NORTHERN VIRGINIA STREAM RESTORATION BANK
 THE GLADE - REACH 6
 Fairfax County, Virginia

Preliminary Plan

Sheet #
4 of 4

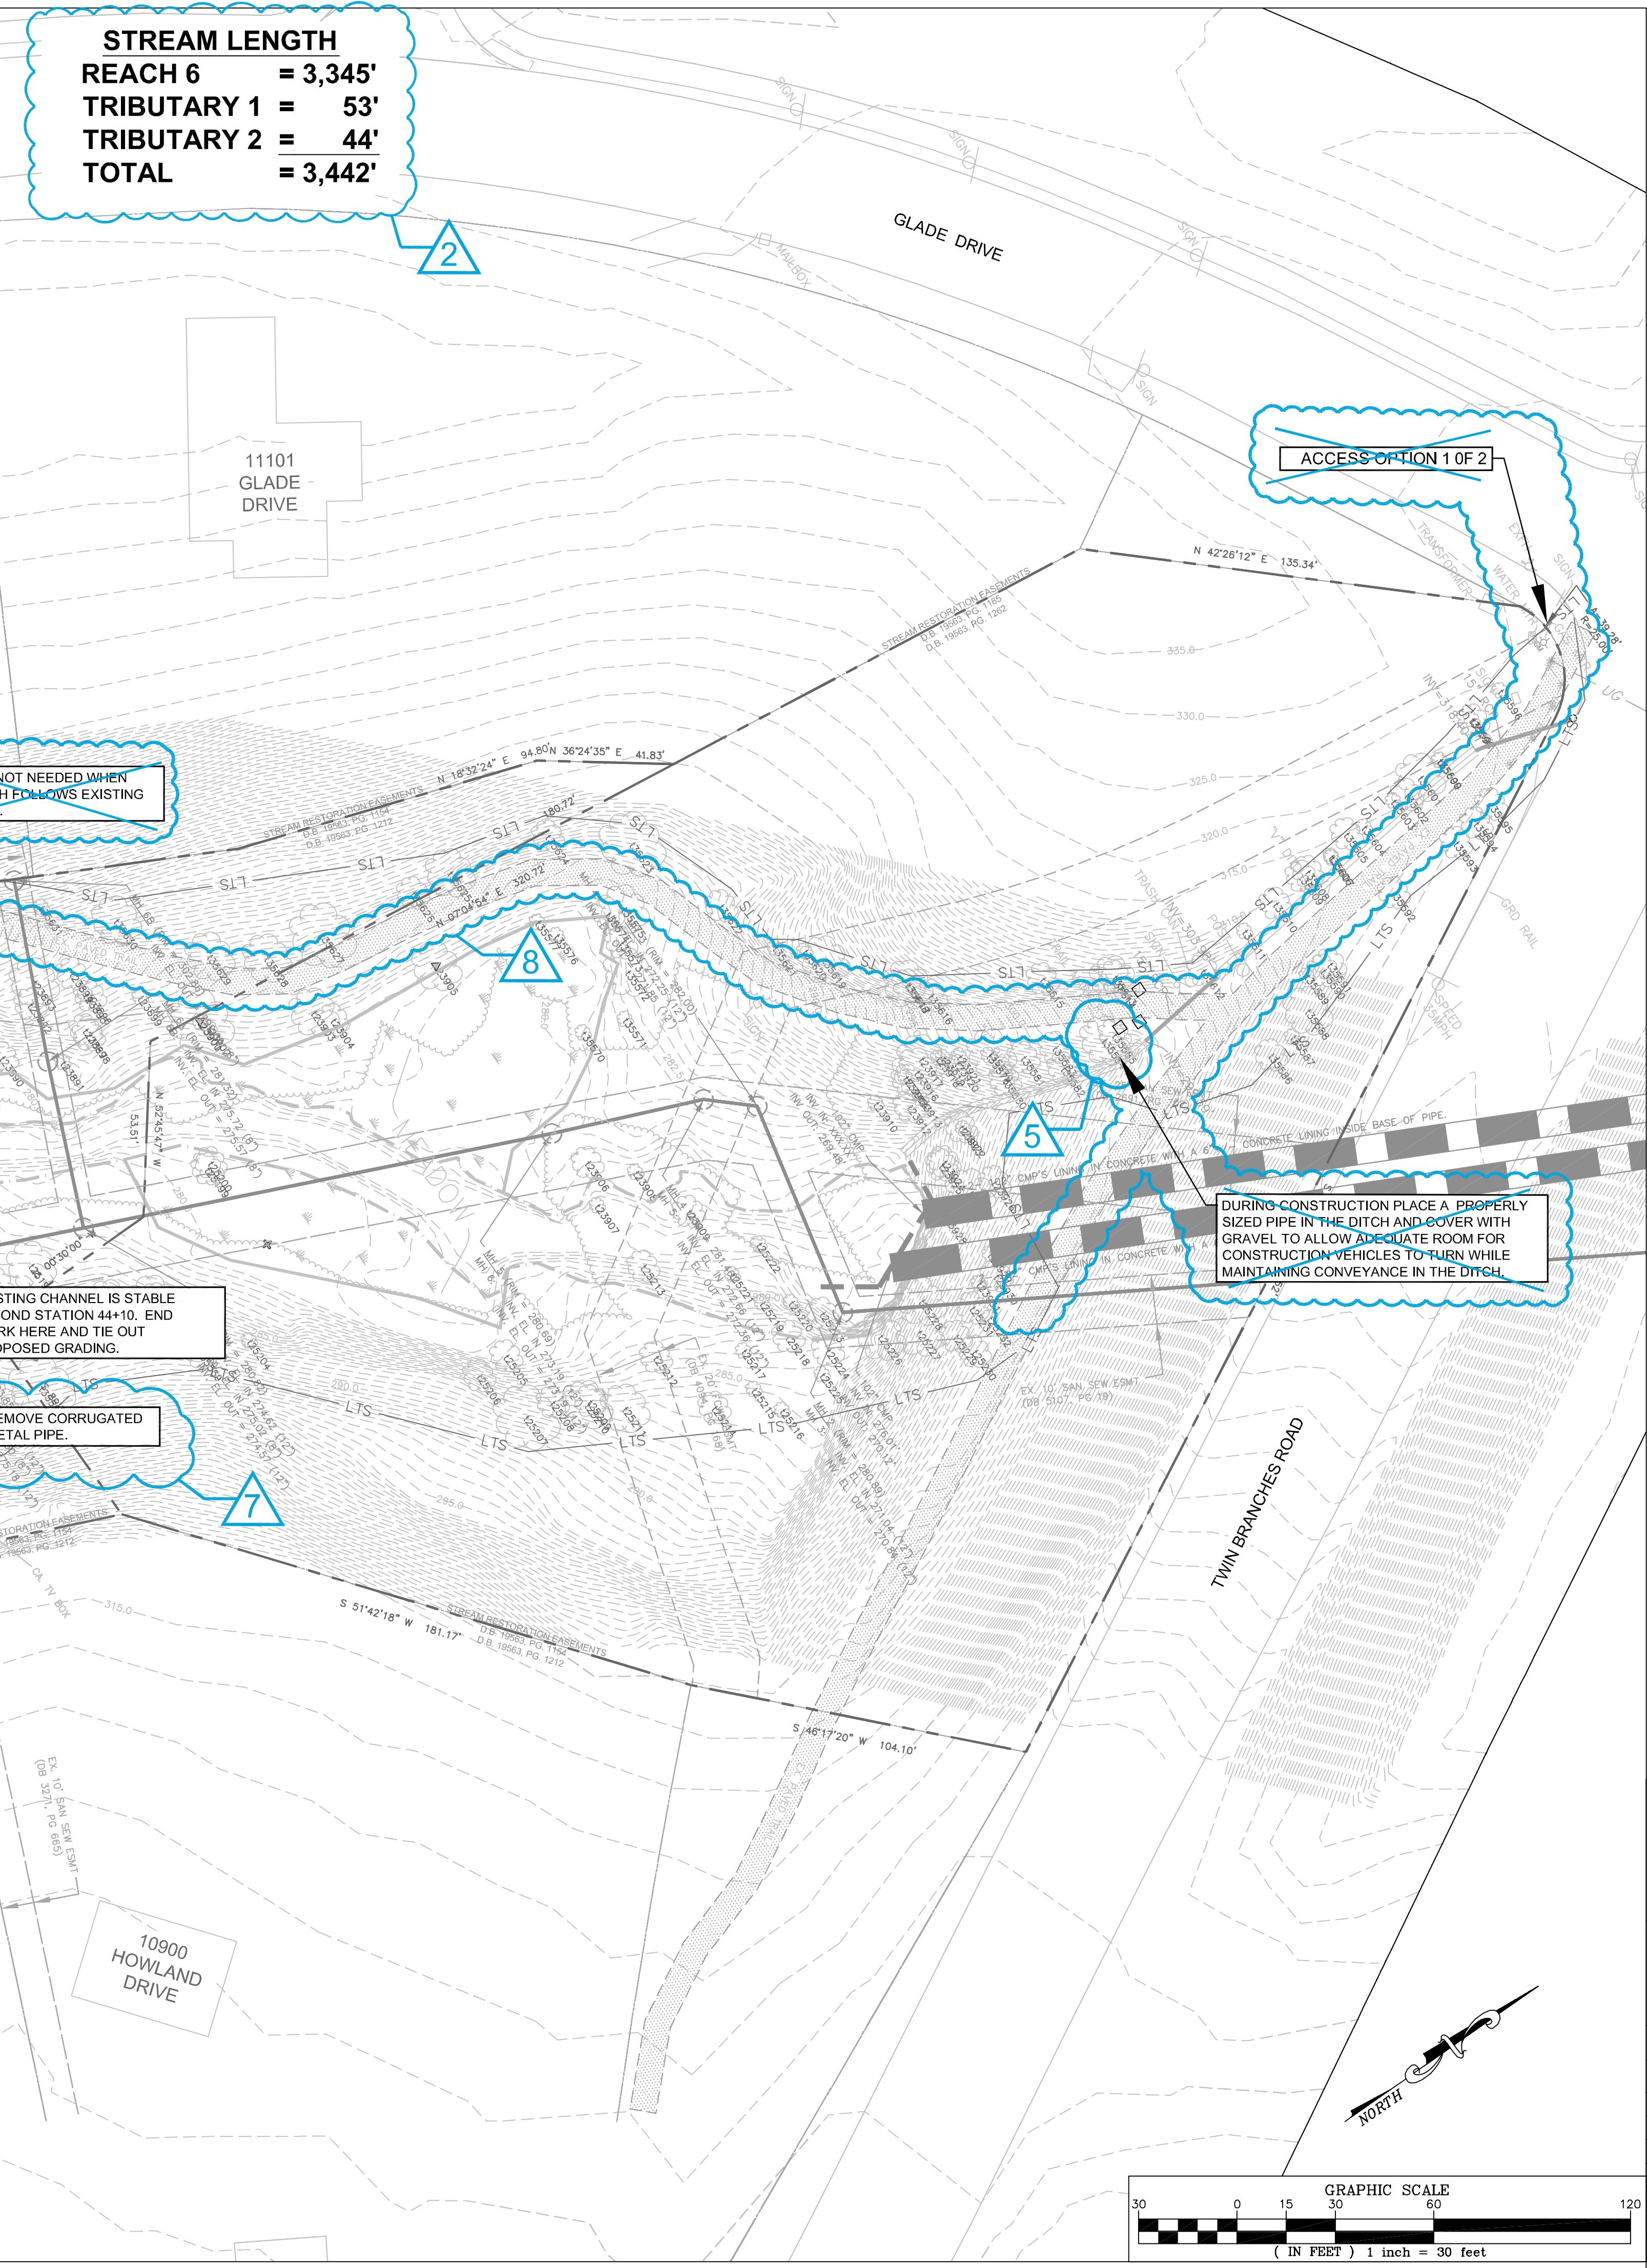
EXISTING CHANNEL IS STABLE BEYOND STATION 44+10. END WORK HERE AND TIE OUT PROPOSED GRADING.

REVISED LIMITS OF CLEARING AND TEMPORARY ACCESS PATH

REVISIONS				REVISIONS					
No.	Date	Description	Rev. By	App. By	No.	Date	Description	Rev. By	App. By
1	7/24/2009	Revised Limits of Clearing and Access Path	SRP	FRG					
2	7/24/2009	Revised alignment; stream lengths	SRP	FRG					
4	7/24/2009	Added trees to be removed (10 Total)	SRP	FRG					
5	7/24/2009	Added trees to be saved (19 Total)	SRP	FRG					
7	7/24/2009	Added grading note	SRP	FRG					
8	7/24/2009	Removed access option 1 & assoc. notes	SRP	FRG
